Re: Butler Supply
2736 NE McBaine Drive
Lee's Summit, MO 64064
Permit No.: PRCOM20251795

June 10, 2025
June 30, 2025 (Revised)

We have received your plan review comments and have itemized our responses to correspond with each comment.

FIELD INSTALLED WEB MEMBERS AT CONCENTRATED LOADS

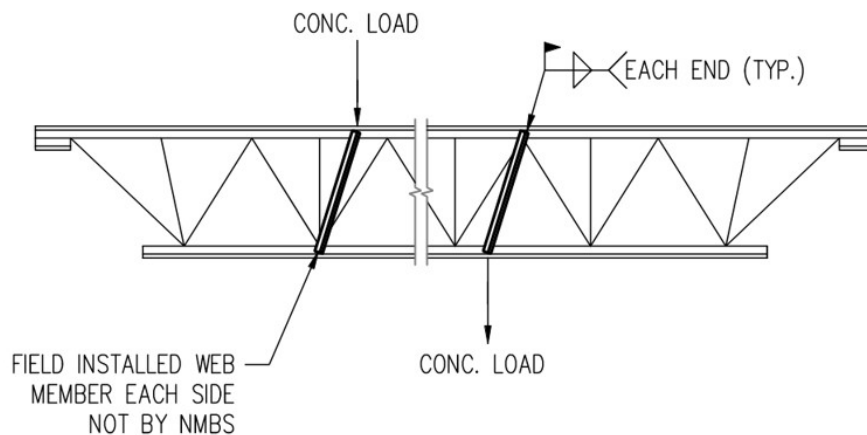
1. Please see the attached email with the diagram and highlighted note from the engineer of the roof truss manufacturer indicating that the existing roof structure is satisfactory to support the new condensing equipment.
 - a. Please see the attached stamped letter addressing the installation of the new condensing units on the roof.
2. Please see the attached engineered rack design detailing the way racks are to be attached to the floor.
 - a. Please see the attached stamped racking design and calcs.

Please reference the "Field Installed Web Members..." detail on sheet J1.1 of our Field Use Drawings. I've highlighted pertinent text in the snip provided below. Considering the added units will impose less than 100# load, the supporting joist members are structurally adequate and do not require field installed reinforcement.

JOIST CHORDS ARE NOT DESIGNED FOR LOCALIZED BENDING FROM CONCENTRATED LOADS – U.N.O. IN LOAD KEY (WHERE SHOWN ON FRAMING PLAN). CONCENTRATED LOADS MUST BE APPLIED AT JOIST PANEL POINTS OR FIELD INSTALLED WEB MEMBERS MUST BE UTILIZED AS SHOWN AT NO COST TO NMBS. ADDITIONAL WEB MEMBERS ARE N.I.N.C. CONSULT THE SPECIFYING PROFESSIONAL FOR SIZING AND WELDING REQUIREMENTS. **ADDITIONAL WEB MEMBERS ARE NOT REQUIRED PROVIDED THAT THE SUM OF THE CONCENTRATED LOADS WITHIN A CHORD PANEL DOES NOT EXCEED 100 POUNDS AND THE ATTACHMENTS ARE CONCENTRIC TO THE CHORD.** REFER TO NMBS JOIST ERECTION NOTES, JOIST INSTALLATION NOTE #12.
